## **Killingly Energy Center (KEC) - NTE Energy Project**

### **Recommendations for CSC Conditions & Third Party Document Review**

## **Killingly Energy Center Response to Third-Party Document Review**

Figure C-1  
Groundwater Flow

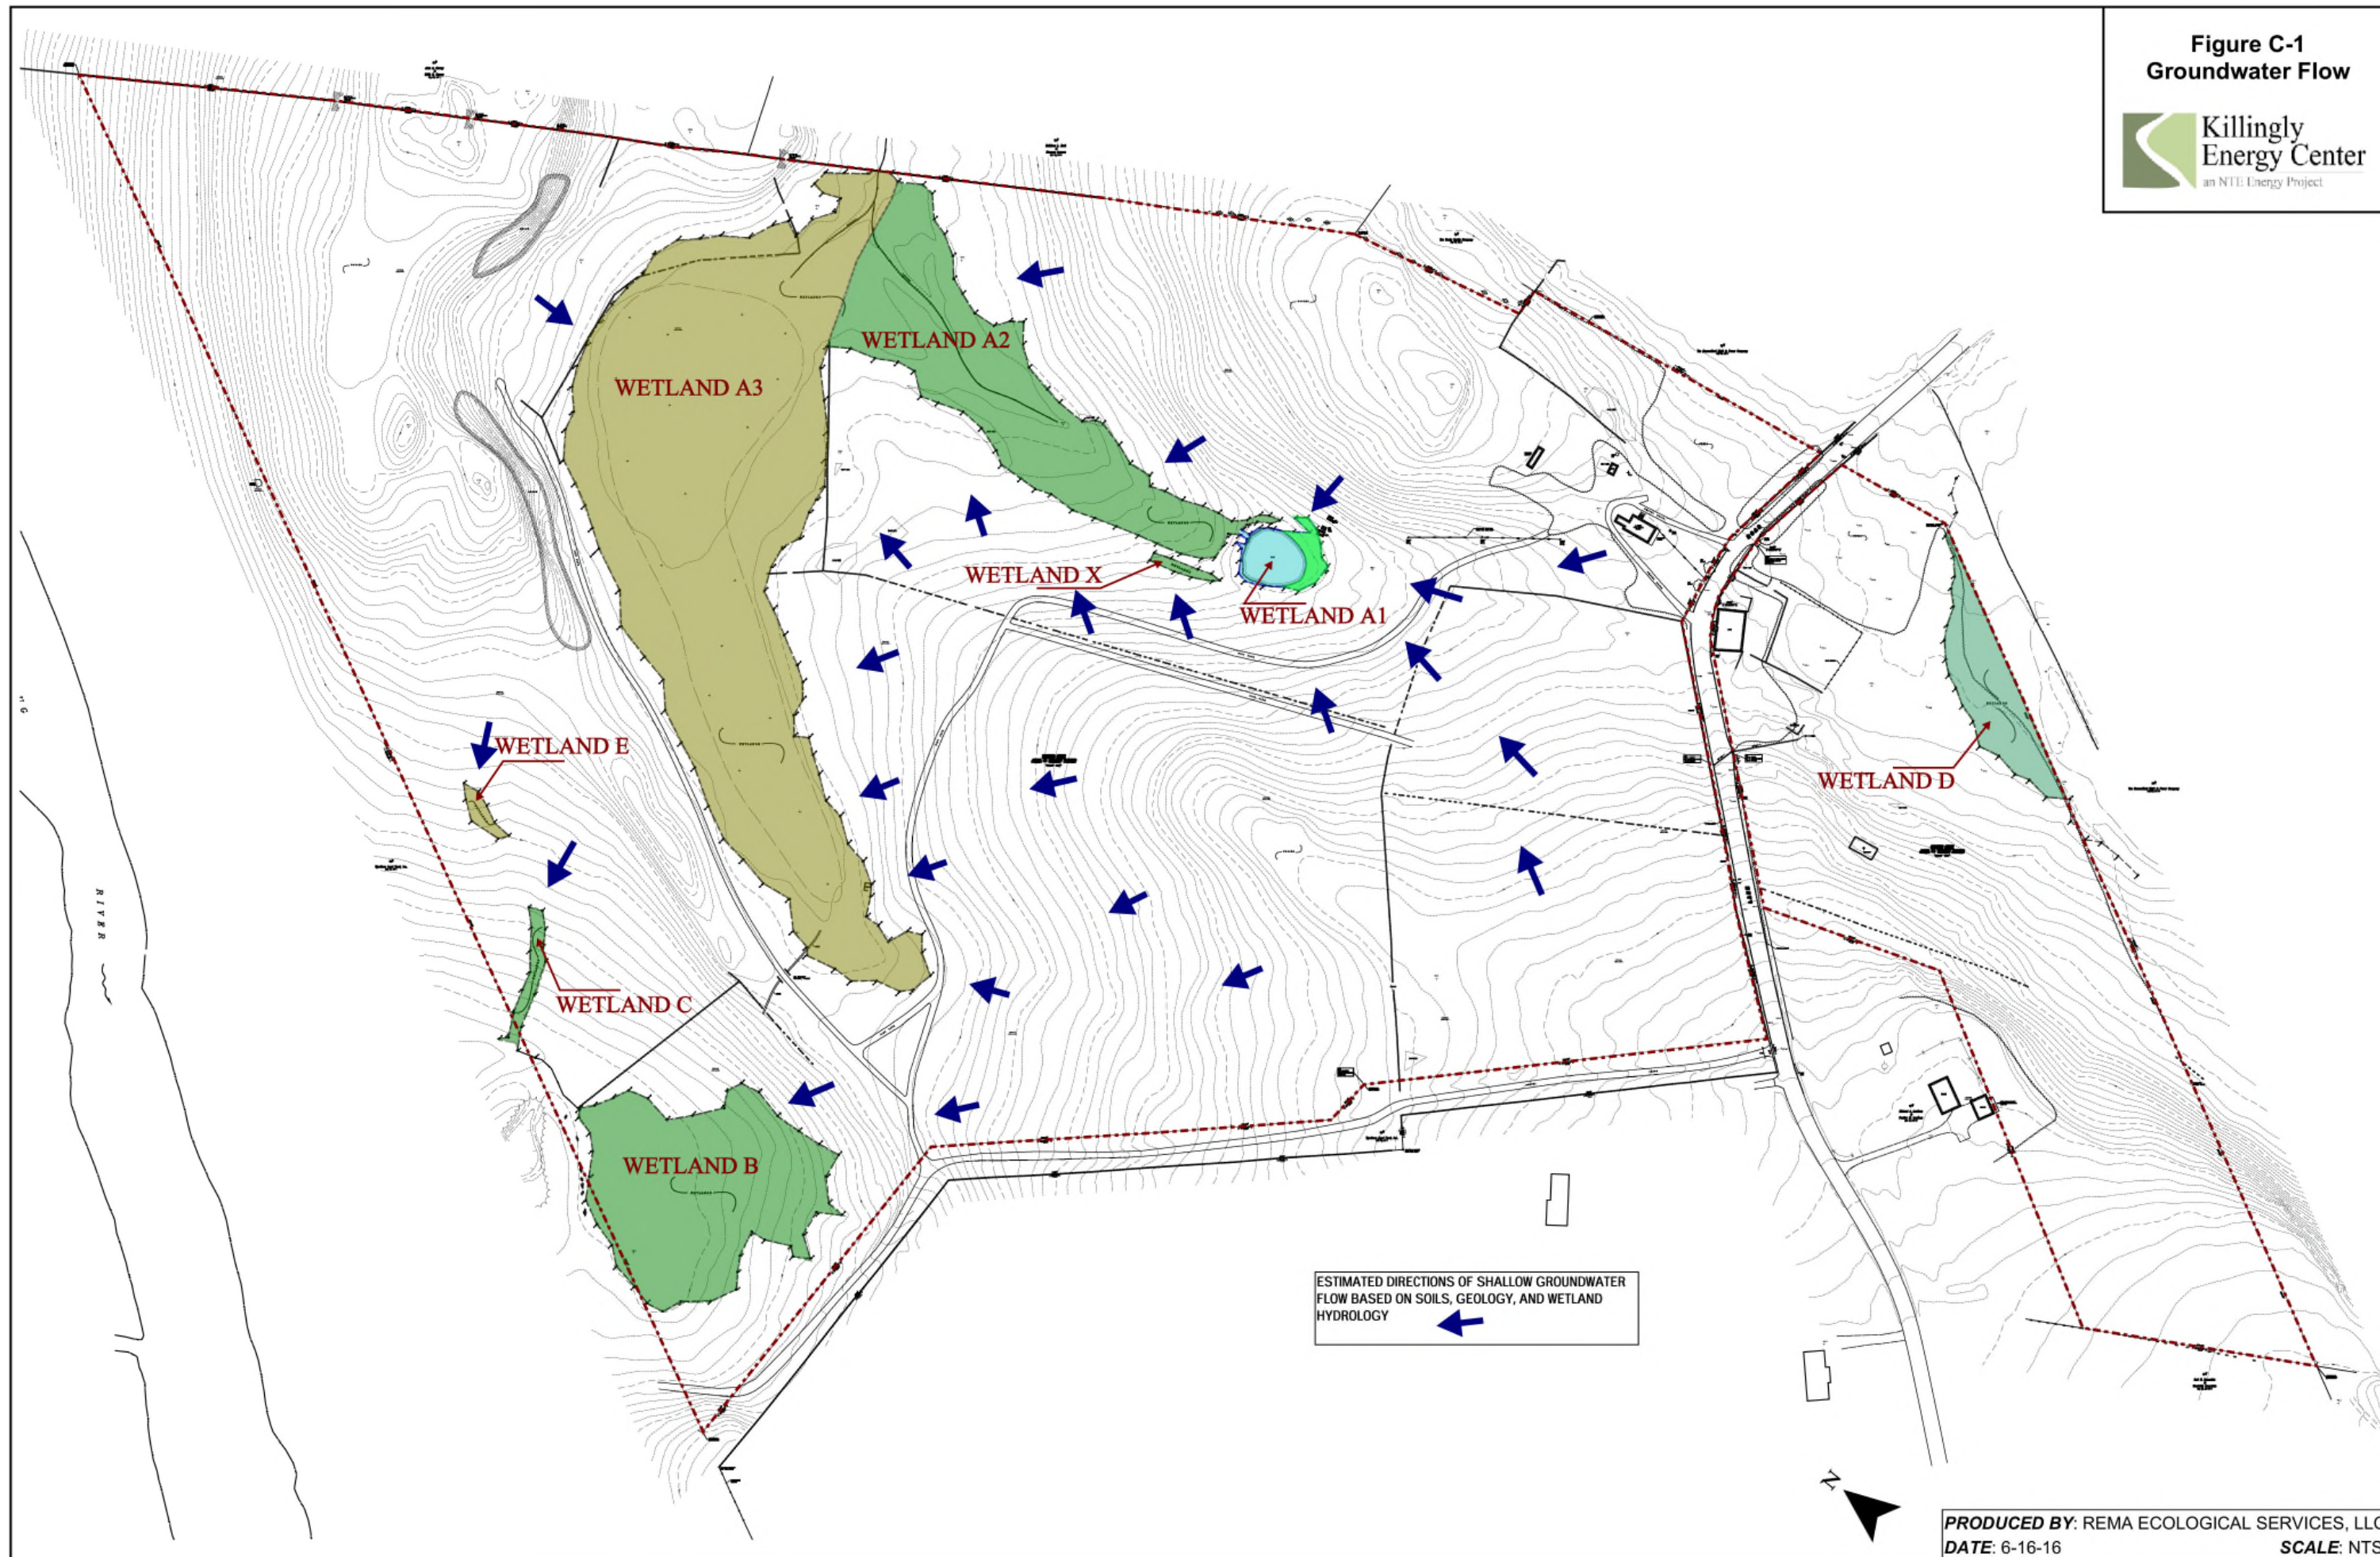
4. The geotechnical report consistently shows that the overburden soils lying below the upper few feet of the soil horizon are generally medium-dense to very dense glacial till. The major grading activities proposed for this site will have significant impact on destroying the existing in-situ soil structure and result in widespread reduction in the infiltrative and recharge capacity of the disturbed site, including areas that are used for temporary staging and laydown. The upper few feet of the stratum on this site with its vegetative cover provide a natural capacity to absorb and retain rainfall percolating through the surface. Once the vegetation is removed and that upper soil structure is disturbed the hydraulic conductivity will drop significantly. The re-grading of the in-situ glacial till across this site will be performed under controlled conditions to achieve 95% or greater optimum densities. With silt/clay fines in the 20% to 40% range the hydraulic conductivity of the uppermost layer of re-graded soils will drop an estimated one order of magnitude to ~~0.00150~~0.0014 in./hr. ( $10^{-6}$  cm./sec.). The problem is that once the upper few feet of soil and vegetation is removed, the new surface will have no capacity to hold, retain, infiltrate and recharge rainfall. Hydraulic conductivity at this low value produces rainfall runoff nearly equivalent to non-pervious estimates for pavement and buildings. Impacts will be discussed further in the storm water comments provided under Appendix D.

*Response C-2:* Groundwater monitoring completed to date was performed in the late spring, when groundwater is typically near seasonal high water level. The data collected in this effort, as well as the detail gathered during the wetland delineation and characterization effort, provide sufficient information from which flow direction and depths can be understood for the purpose of design. Because the intermittent stream systems and associated wetlands are fed by groundwater springs, the expected direction of groundwater flow can be illustrated as shown in Figure C-1.

Figure D-1  
Location of Vernal Pool

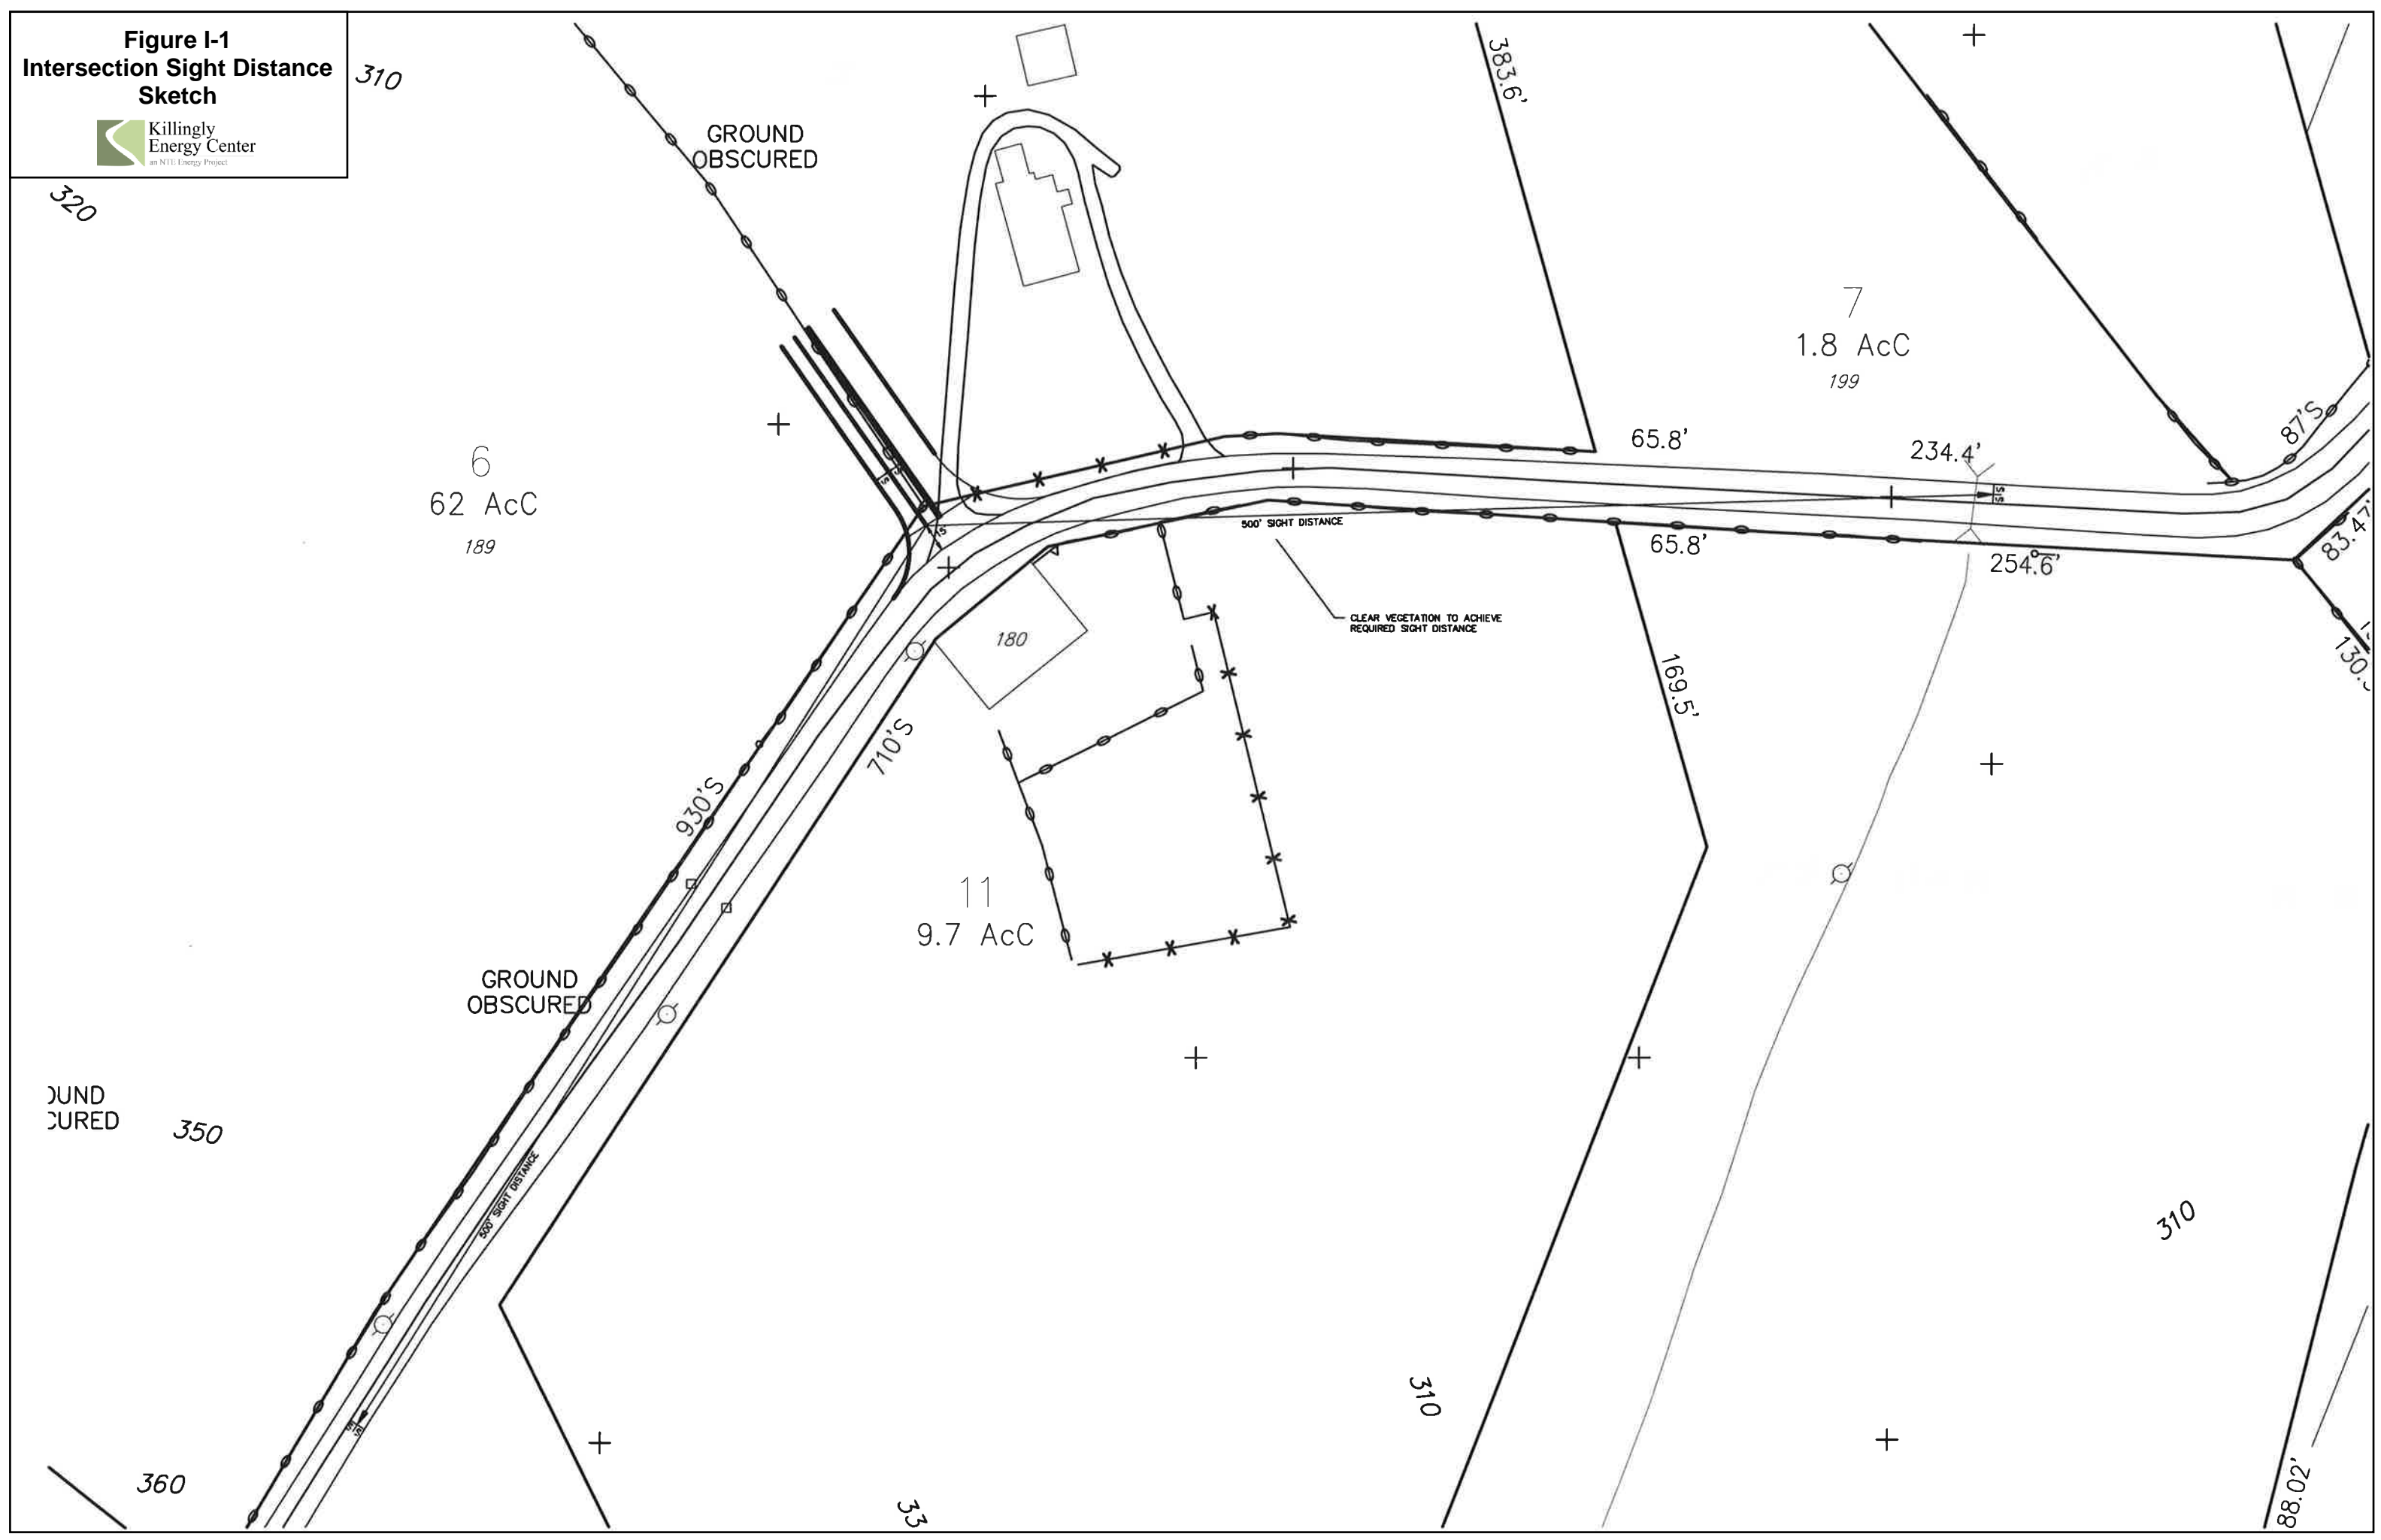
1. The location of special aquatic sites such as the vernal pool present within Wetland B need to be identified and depicted on site plans. In addition, if located within 200 feet of any proposed site activities, the location of the off-site vernal pool needs to be depicted and impacts to this area evaluated.

*Response D-14:* As also noted in response E-6, the pool component of the detention basin is desirable and is at a sufficient distance (greater than 750 feet) from the vernal pool (see Figure D-1). If additional similar basins are added in response to Town request, one could be located within 750 feet of the vernal pool. Design of all such basins will incorporate dense vegetation and structures to discourage its ability to act as a "decoy" for amphibians and will include standard plastic fencing that will prevent access by such species.

*Response E-6 and E-10:* The current basin is more than 750 feet from the vernal pool in Wetland B (see Figure D-1). However, other basins – if added – could be closer. In order to retain the value of the wet basin design but prevent inadvertently attracting vernal pool amphibians, a simple barrier will be installed to encircle the basin (constructed of metal stakes and plastic netting, and reaching approximately 1 foot in height).

**Figure I-1**  
**Intersection Sight Distance**  
**Sketch**

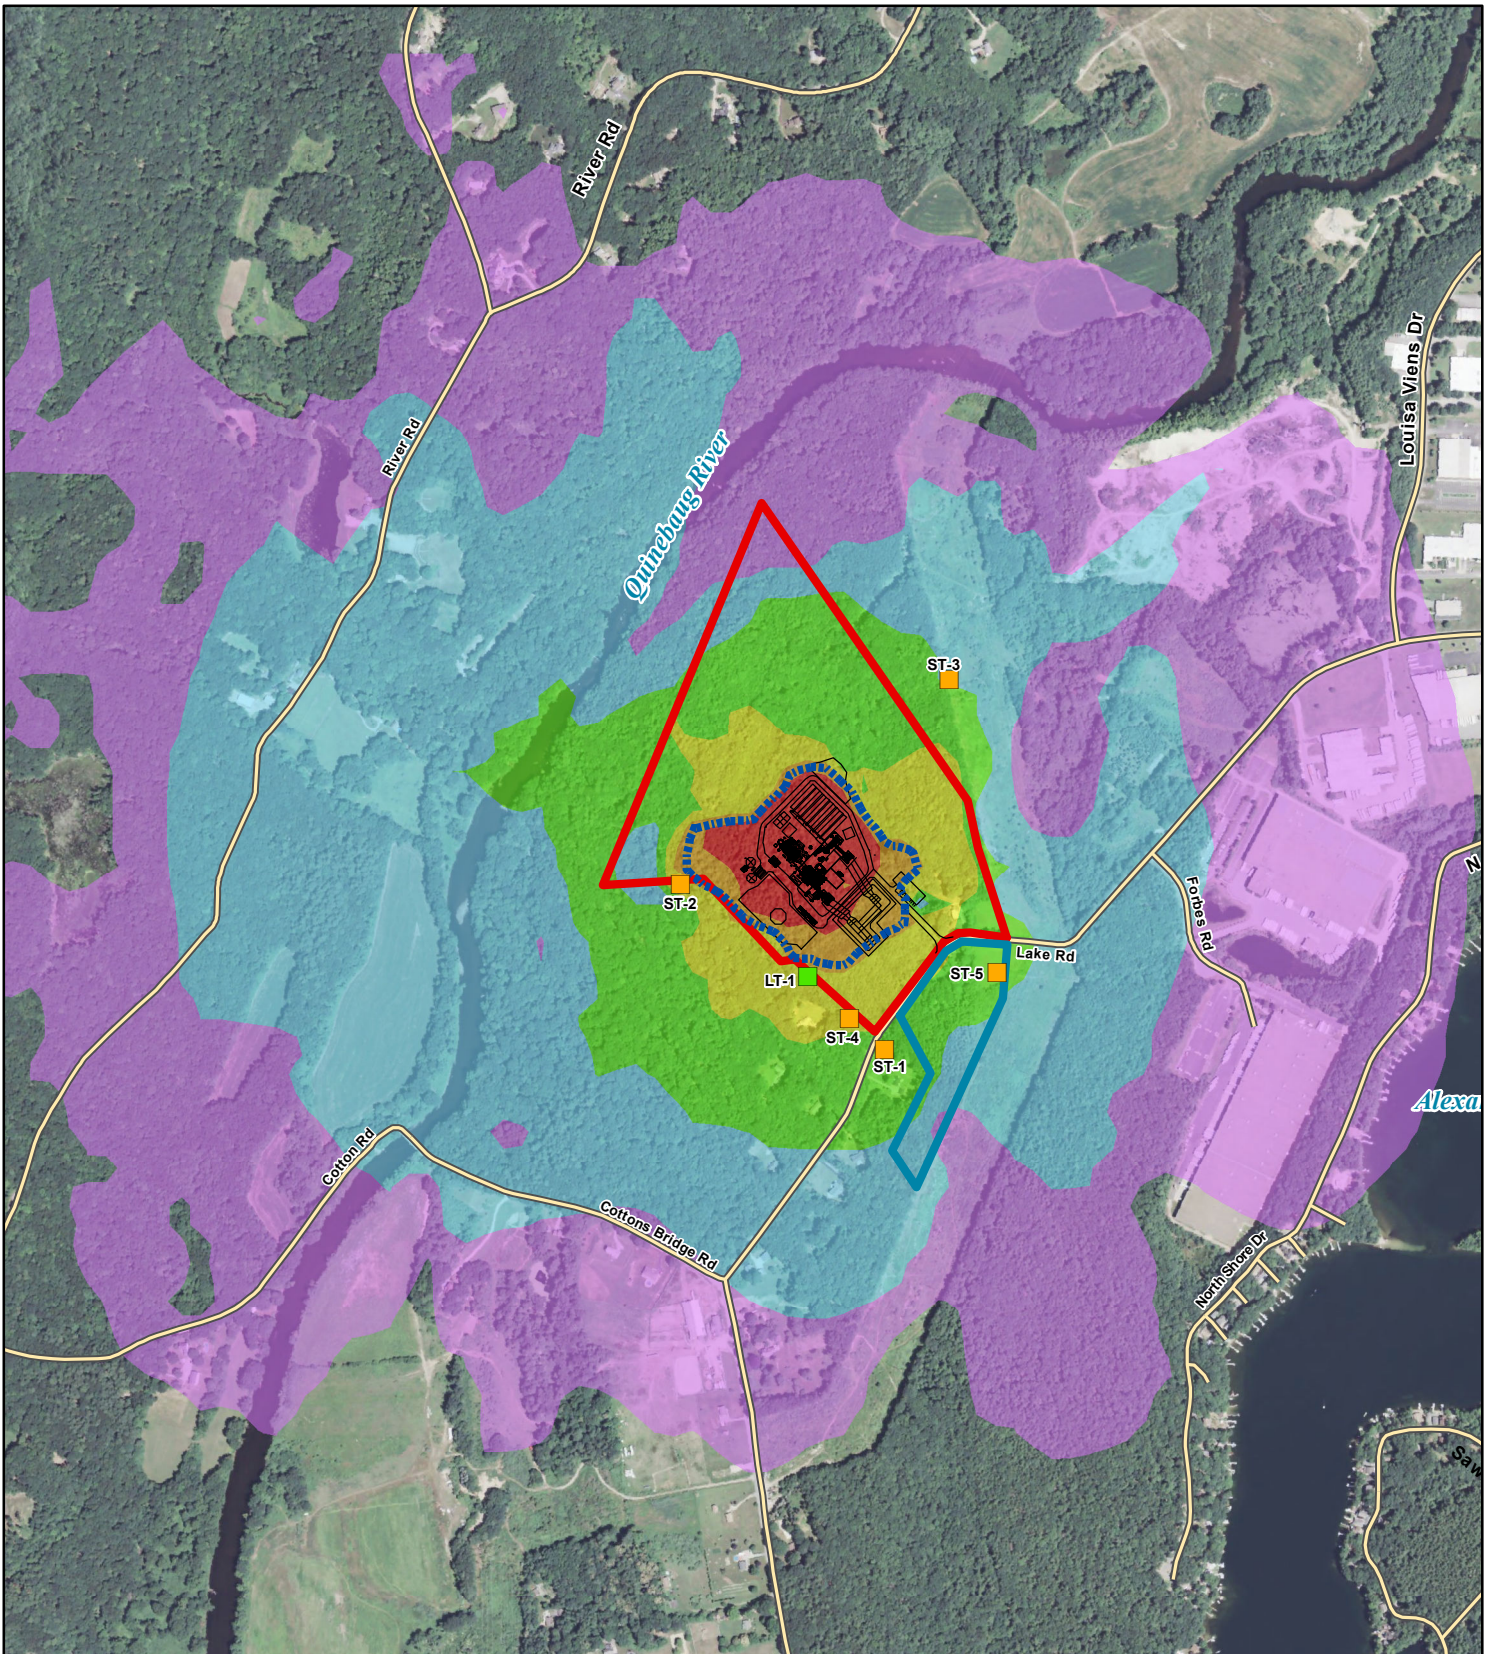
8. More information should be provided regarding the modifications/widening of the curves along Lake Road. This should be coordinated with the Town and the work should be performed at the beginning of the construction process. It should be determined why the sign on Lake Road prohibiting trucks past a certain point was installed.

*Response I-24:* The available intersection sight distances are shown in Figure I-1.
